**CERTIFICATE OF APPROPRIATENESS**

TAX MAP N°: 68 PARCEL N°: 246  
Street & Number of Proposed Work: 21 OLD SOUTH RD  
Owner of record: JOHN READY  
Mailing Address: PO BOX 2165  
EDGARTOWN, MA 02538  
Contact Phone #: \_\_\_\_\_ E-mail: \_\_\_\_\_

New Dwelling  Addition  Garage  Driveway/Apron  Commercial  Historical Renovation  Deck/Patio  Steps  Shed  
 Color Change  Fence  Gate  Landscaping  Move Building  Demolition  Revisions to previous Cert. No. 66375  
 Pool (Zoning District \_\_\_\_\_)  Roof  Other MODIFIED FENCE & ADDED/RELOCATED MECH. EXHAUST.  
Size of Structure or Addition: Length: NO CHANGE Sq. Footage 1st floor: NO CHANGE Decks/Patio: Size: \_\_\_\_\_  1st floor  2nd floor  
Width: \_\_\_\_\_ Sq. footage 2nd floor: \_\_\_\_\_ Size: \_\_\_\_\_  1st floor  2nd floor  
Sq. footage 3rd floor: \_\_\_\_\_

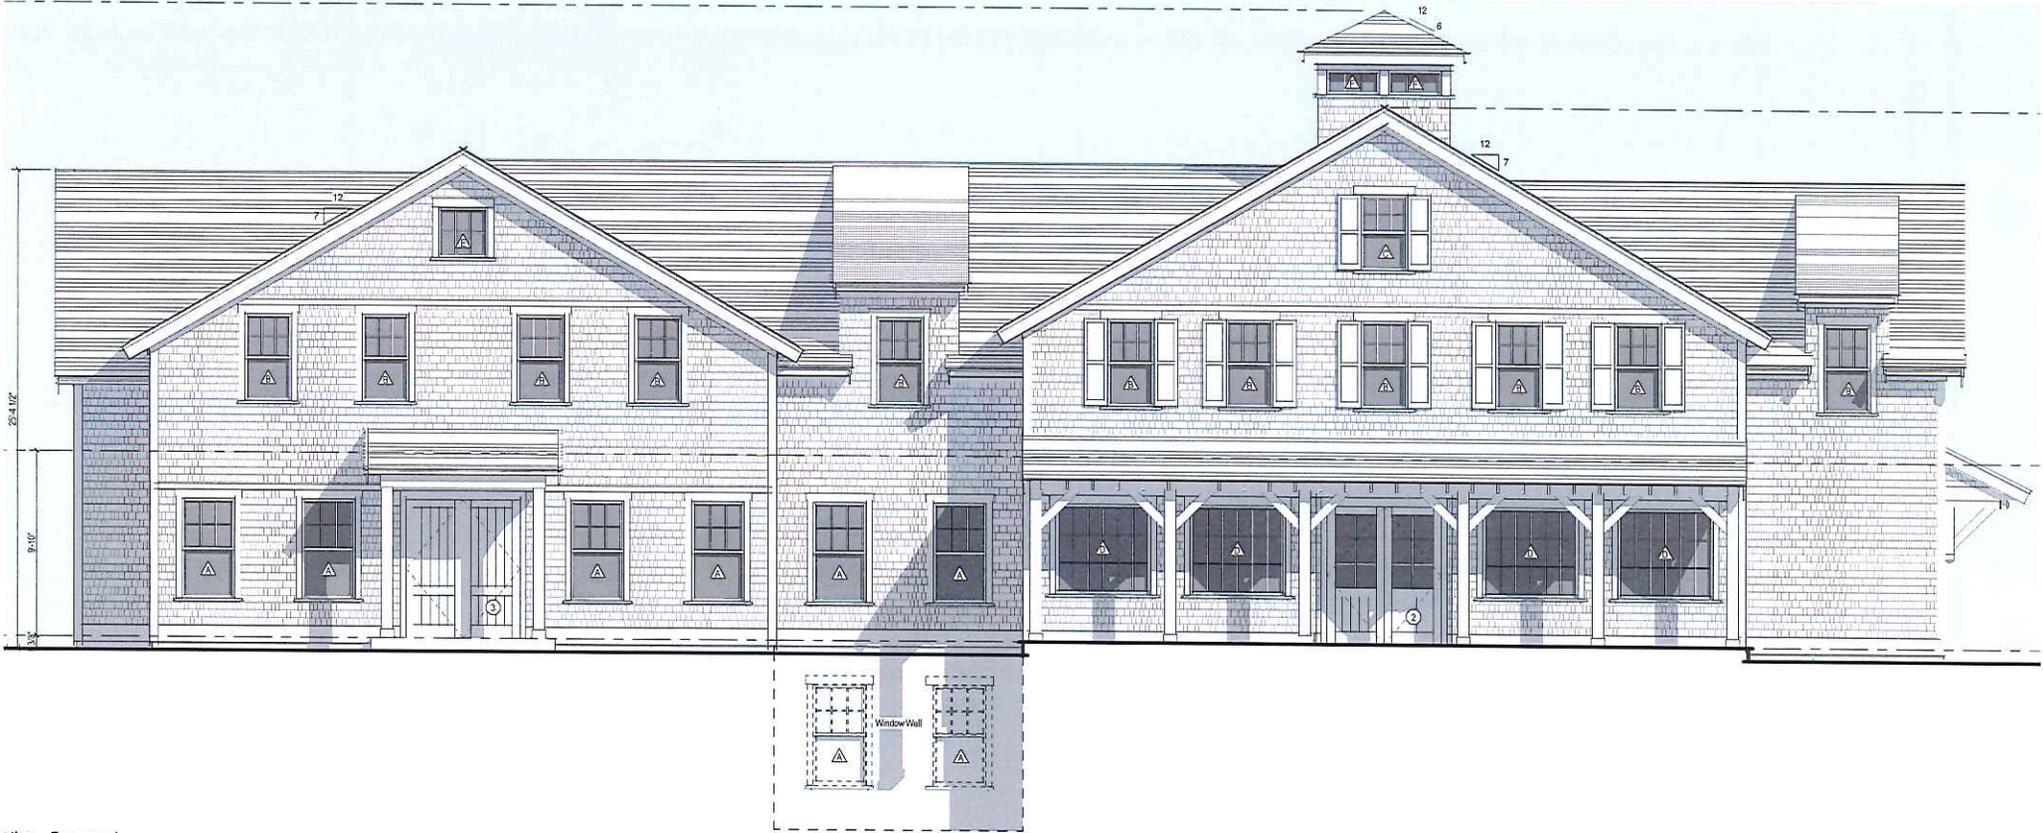
Added 12" Diam. Elevator Exhaust Ventilation Outlet

Eliminated 1 & Rescaled 2nd Kitchen Exhaust Fan
